# UNITED STATES PATENT AND TRADEMARK OFFICE

10/574,485

# Office Action Summary

## **DETAILED ACTION**

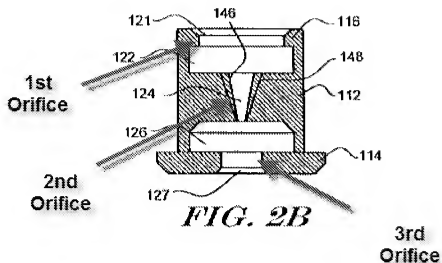
**In regard to claim 5**, Takahashi teaches of the limitations of claim 1, but fails to teach of the fluid-air channel being a double cavity channel and containing a septum that's used as a valve.

Shalit teaches of a closed system irrigating apparatus for viscus organs, wherein it comprises a pressure inlet tube **(48)** and a pressure outlet tube **(50)** and the tubes are separated by a septum **(12)** that can swing left and right as fluid flows through the tubes and a pair of check valves **(36, 38)** that prevent backflow of fluid **(Col. 1, Lines 29-44)**.

It would have been obvious to one of ordinary skill in the art at the time of the invention to provide the sheathed endoscope of Takahashi with the irrigating apparatus of Shalit to provide the endoscope with both inlet and outlet ports and prevent the two lines from contaminating each other.

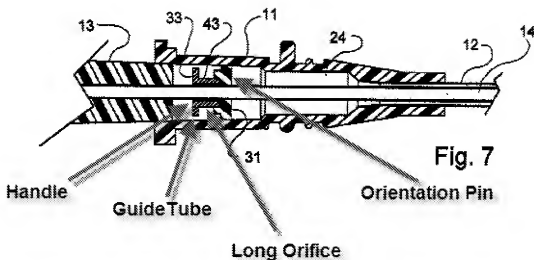
**In regard to claim 8**, Takahashi teaches of the limitations of claim 7, but fails to teach of the three way sealing cap containing three elastic sealing orifices and the guide tube containing an orientation pin within the long orifice.

Carrillo teaches of a fluid seal for endoscopes wherein when placed into the three-way sealing cap **(14)** of Takahashi provides the structure required by the three-way sealing cap of applicant. Carrillo's sealing cap contains three sealing orifices **(see Fig. 2B below)**, wherein the guide tube can be placed within the three way seal.

Vaillancourt teaches of a bloodless catheter wherein a guide tube (see Fig. 7 below) comprises an orientation pin (see Fig. 7 below) that is inserted into a hub (11) and helps facilitate the passage of a needle hub (13) through the guide tube. The guide tube of Vaillancourt could be used with the 3-way seal provided by Carrillo and Takahashi by inserting the guide tube into the 3-way seal and the orientation pin would be pushed over the 3rd elastic sealing orifice (see Fig. 2B above).

It would have been obvious by one of ordinary skill in the art at the time of the invention to provide the sheathed endoscope of Takahashi with the 3-way fluid seal of Carrillo and the guide tube of Vaillancourt to provide seals preventing the endoscope from becoming contaminated allowing devices to be used multiple times.
